Licence Number	L6942/1997/13
Licence Holder	BHP Billiton Iron Ore Pty Ltd
ACN	008 700 981
File Number:	DER2013/000329
Premises	Eastern Ridge Iron Ore Mine Mining Tenement ML244SA within coordinates MGA Zone 50: NEWMAN WA 6753 As depicted in Schedule 1, Maps and co-ordinates
Date of Amendment	22 March 2019

Amendment

Amendment Notice

Figure 1: Layout of the 5 mtpa relocatable crusher at Orebody 25

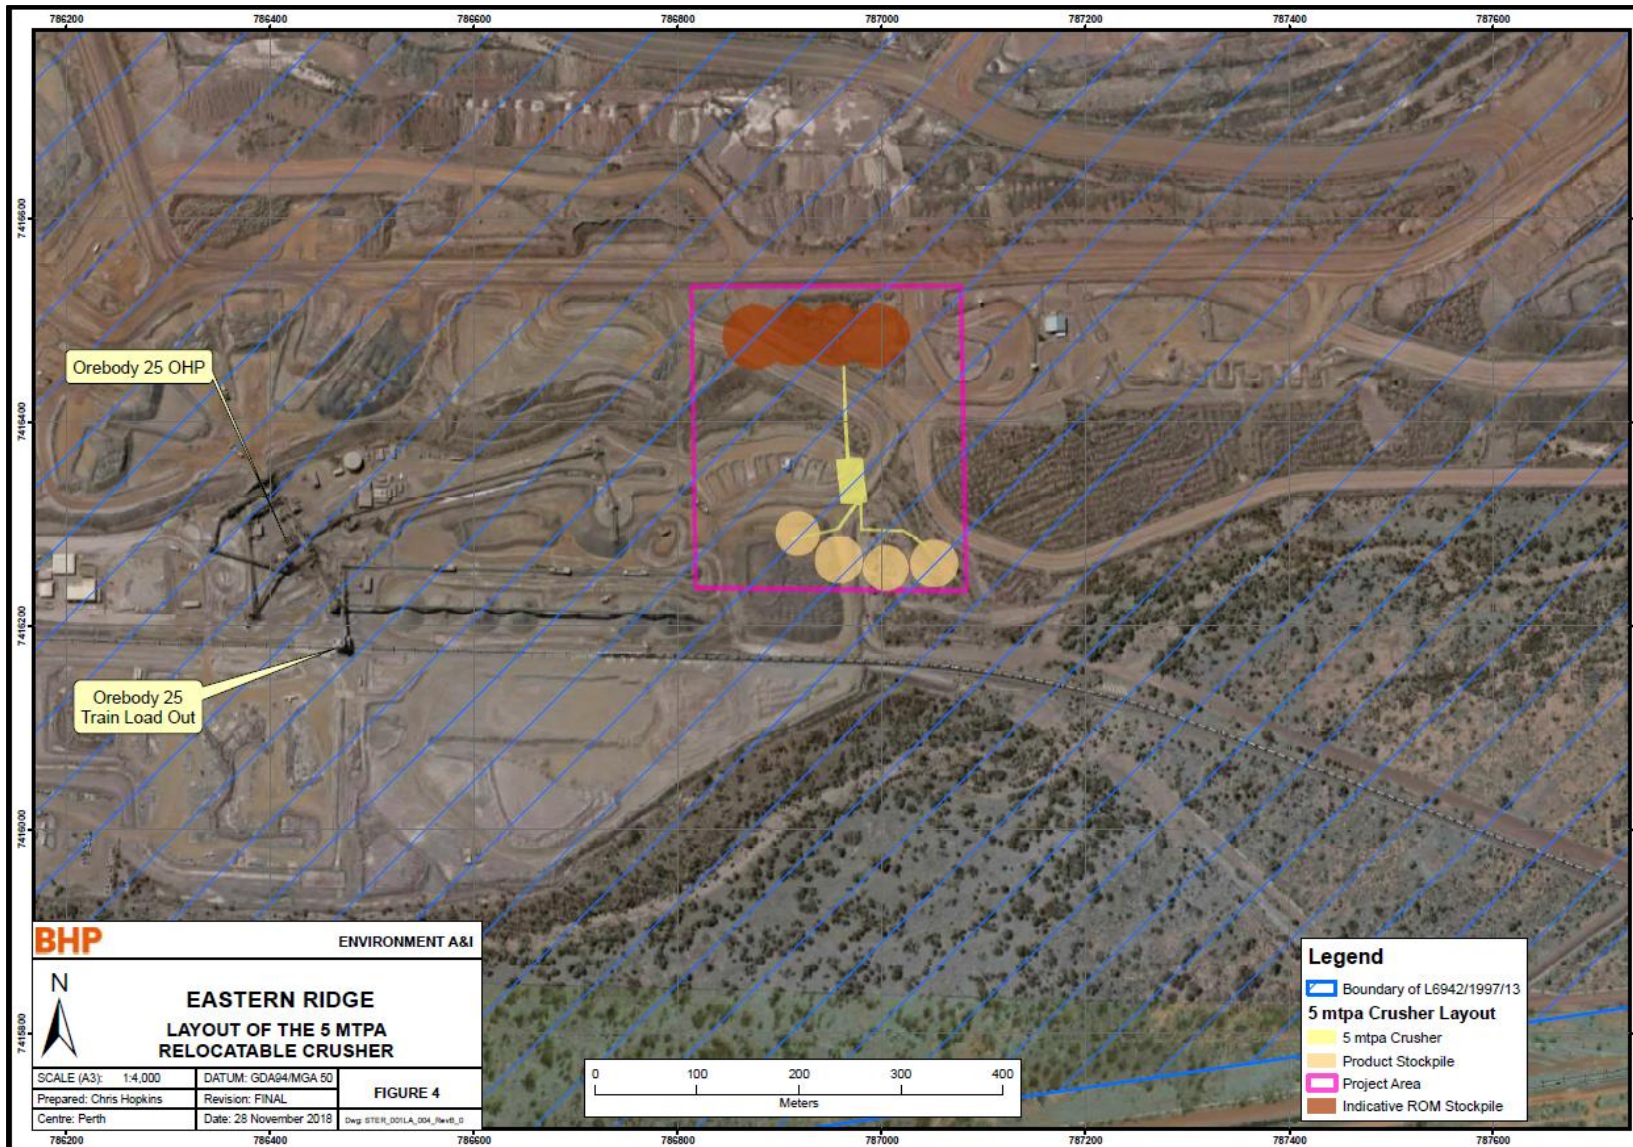
The Licence Holder is also proposing to construct and operate a 5 mtpa relocatable crusher at Orebody 25. The relocatable crusher will comprise of the following components, and be located within previously cleared areas at Orebody 25, as shown in Figure 1:

- A modular Primary Crusher;
- Run of Mine (ROM) Bin;

- Various conveyors;
- Two radial stackers;
- Two secondary HP4 cone crushers;
- Three screens; and
- Two sample stations.

The ROM tipping and plant feed area will consist of a compacted earth ROM tipping platform and associated ROM stockpile fingers. Tipping will be done alternatively on the fingers. Feeding of the crusher plant will be by direct tipping with front end loaders. Product from the crushers and screens will be deposited on plant product piles by conveyor belts and stackers.

There will be two ore for rail stockpiles, with a total stockpile capacity of appropriately 120,000 tonnes. Ore will be pre-loaded directly on trains or loaded through the existing train load out facilities at Orebody 25.

<u>5 mtpa Relocatable crusher</u>	<ul style="list-style-type: none"> • <u>A modular Primary Crusher;</u> • <u>Run of Mine (ROM) Bin;</u> • <u>Various conveyors;</u> • <u>Two radial stackers;</u> • <u>Two secondary HP4 cone crushers;</u> 	<u>Schedule 1, Map1 – infrastructure labelled 'Orebody 25 5 Mtpa Relocatable Crusher'</u>

<ul style="list-style-type: none"> • <u>Three screens; and</u> • <u>Two sample stations.</u> • <u>ROM tipping and plant feed area consisting of a compacted earth ROM tipping platform and associated ROM stockpile fingers.</u> 	
--	---	--

Figure 2: Town Centre (Newman 1) wind arc

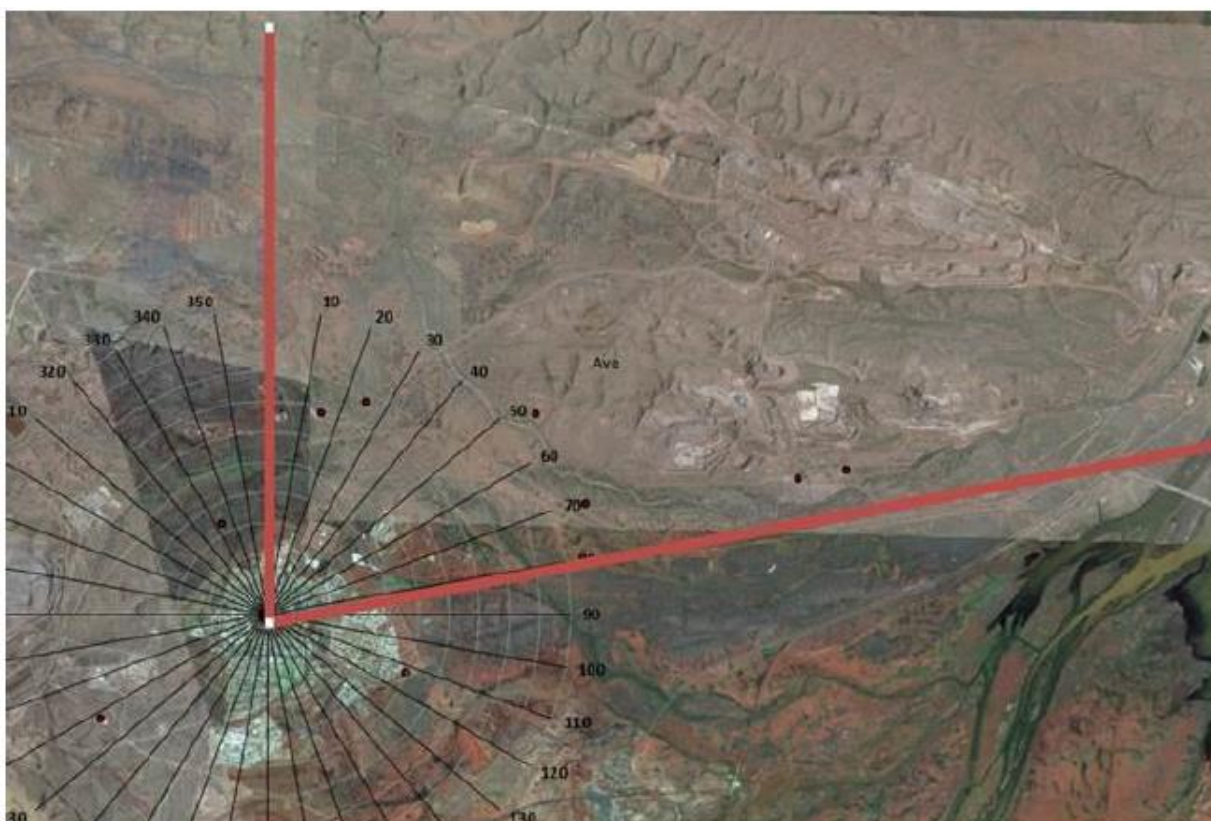
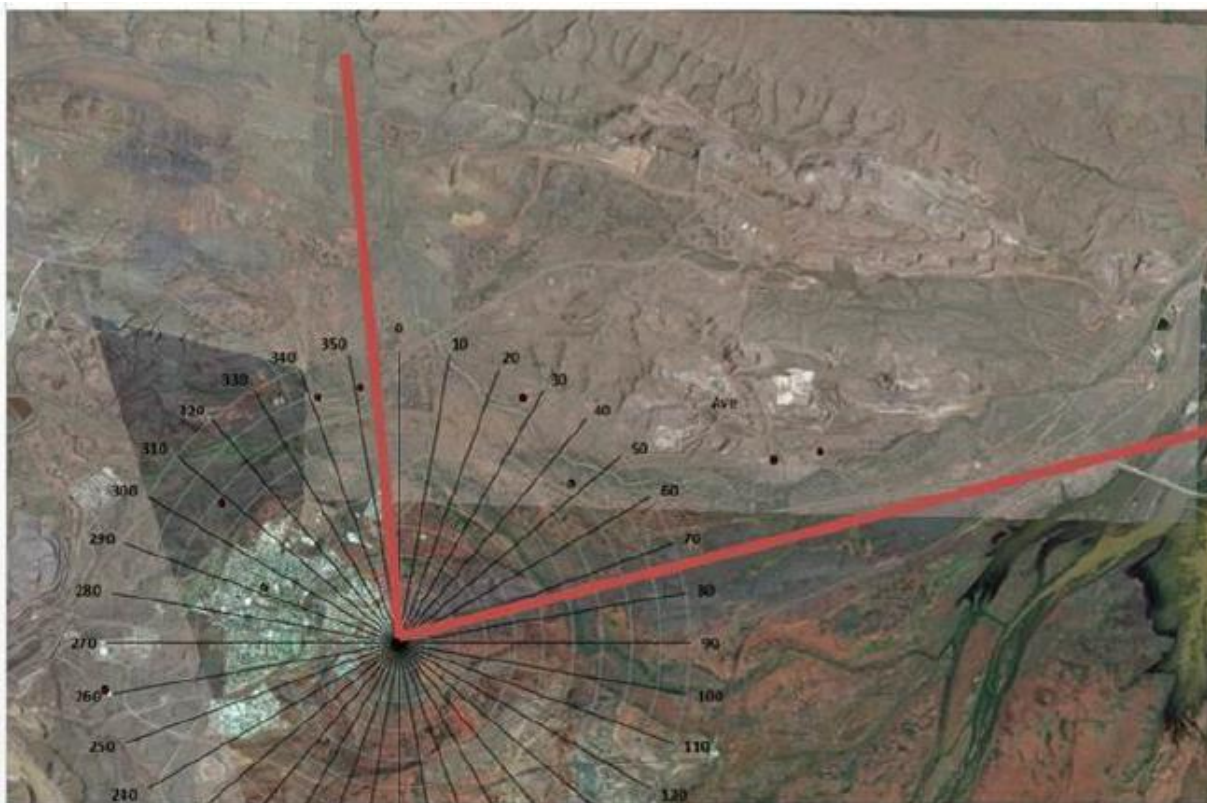
The fixed ambient air monitors are utilised to determine PM₁₀ levels and potential impacts on the town. The wind arcs utilised by the Licence Holder to indicate potential PM₁₀ levels that has originated from the Premises are provided below as Figures 2 and 3.

Map 1 – Premises Map with key infrastructure. The blue line depicts the Premises boundary.

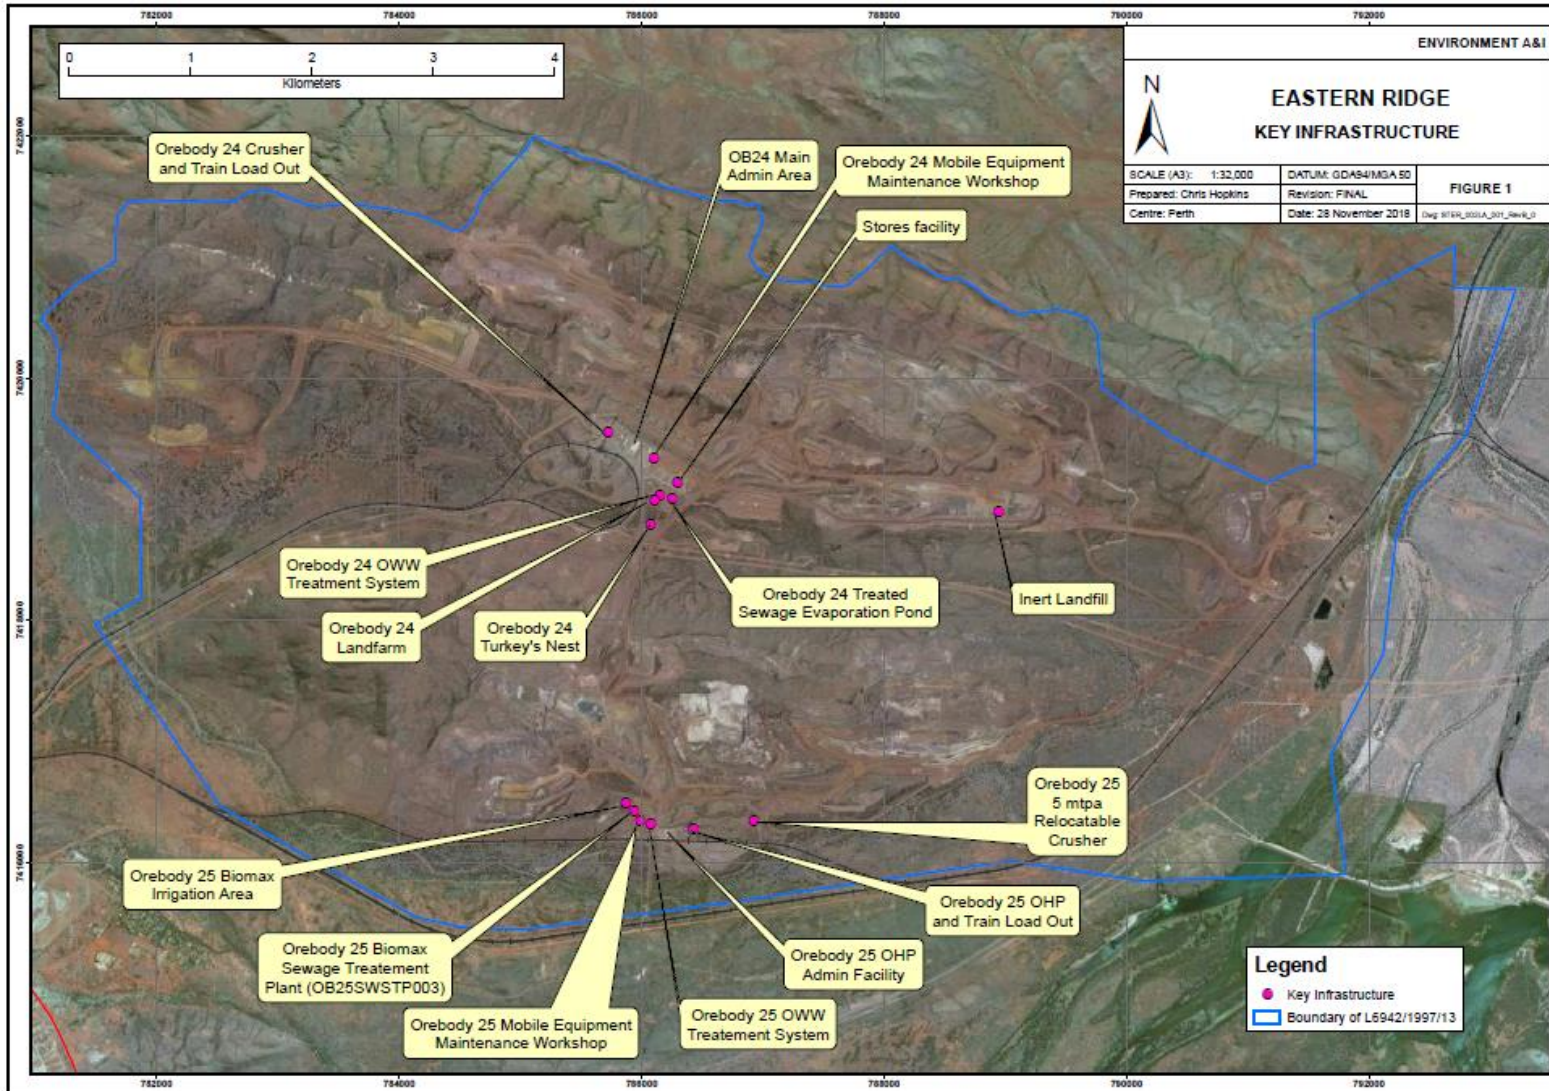
8. Schedule 1: Maps and coordinates, *Map 1* of the Licence is replaced by the map shown in Attachment 1.
9. Schedule 2: Reporting & notification forms, *Annual Audit Compliance Report Proforma* of the Licence is removed.
